**Committee of Experts on the Transport of Dangerous Goods  
and on the Globally Harmonized System of Classification  
and Labelling of Chemicals****Sub-Committee of Experts on the Transport of Dangerous Goods****Sixty-third session**

Item 6 (c) of the provisional agenda

**Miscellaneous proposals for amendments to the Model Regulations  
on the Transport of Dangerous Goods:****Portable tanks****Requirements for design, construction, inspection and testing  
of fibre reinforced plastic (FRP) service equipment for  
portable tanks****Transmitted by the expert from the Russian Federation on behalf of the  
informal working group on FRP service equipment\*****I. Introduction**

Figure 42.3.1: Fire resistance test scheme

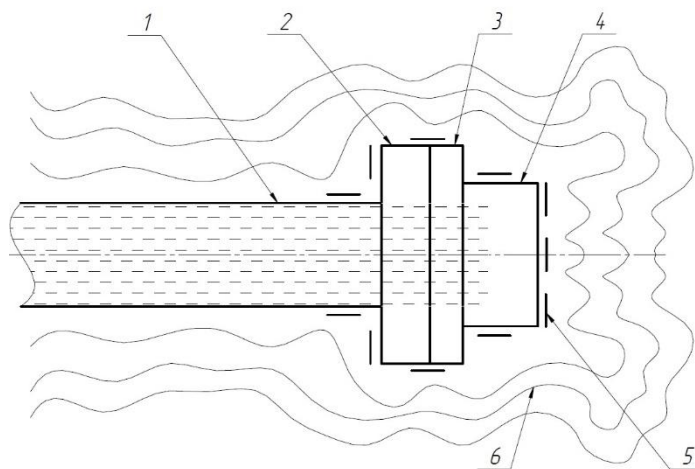
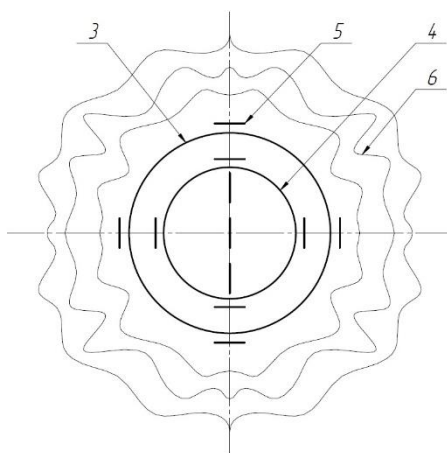
42.3.1 The fire resistance test is carried out for the test specimen installed in a closed position, filled with water with initial temperature of  $20 \pm 5^\circ\text{C}$  under maximum allowable working pressure (MAWP, 6.7.2.1 of the *Model Regulations*), and exposures to flame for at least 30 minutes. The test specimen shall be completely engulfed in the flame including the gate and seal assemblies. The general test scheme is given in figure 42.3.1. If the test specimen is an part of equipment which is not intended to be the outermost closure in a multi-closure system (such as a valve), then the test specimen may be equipped with a blind flange, at its outermost interface which would otherwise be exposed to flame during the test.

- (a) a fire chamber with dimensions sufficient to accommodate the test specimen and the temperature and heat flux measuring system;
- (b) a fuel supply and combustion system;
- (c) a pressure system with water supply ((1) in figure 42.3.1);
- (d) a fixture to join the test specimen to the test bed ((2) in figure 42.3.1); and
- (e) a temperature and heat flux measuring system ((5) in figure 42.3.1) according to ISO 21843:2018.

42.4.2.2 The general scheme of installation of the test specimen and temperature and heat flow sensors is shown in figure 42.3.1. Measurement errors shall not be more than:
